Preliminary ADA Assessment at New York Central Park

Major ADA Violations Found at Every Location Assessed

Stair (new) and Ramp Inside Park

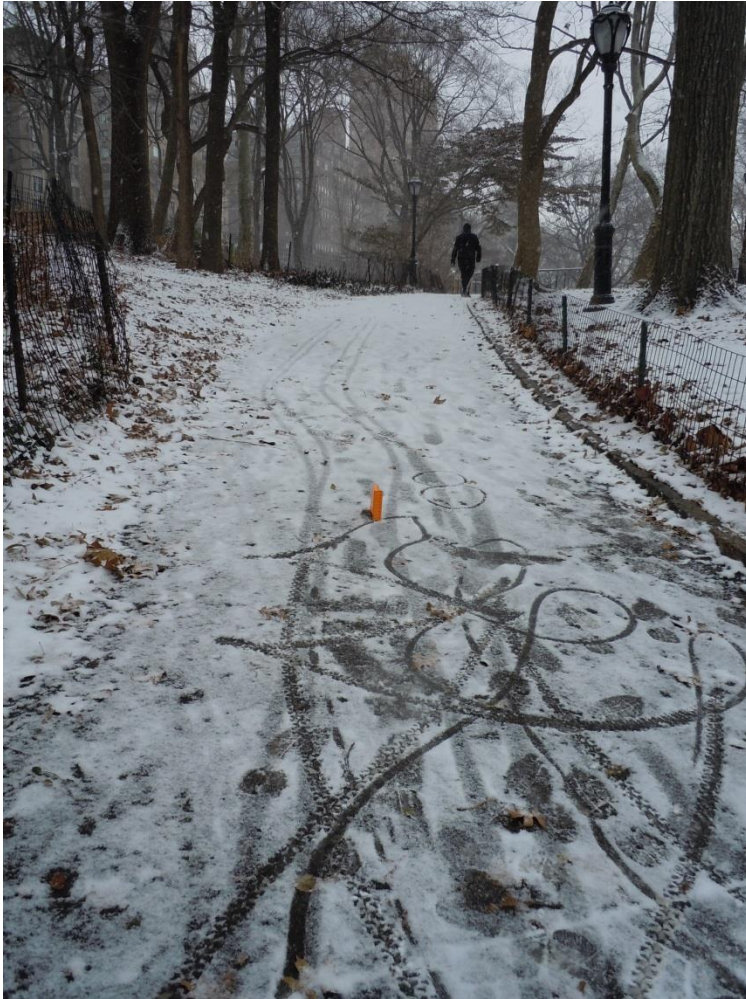
New lumber
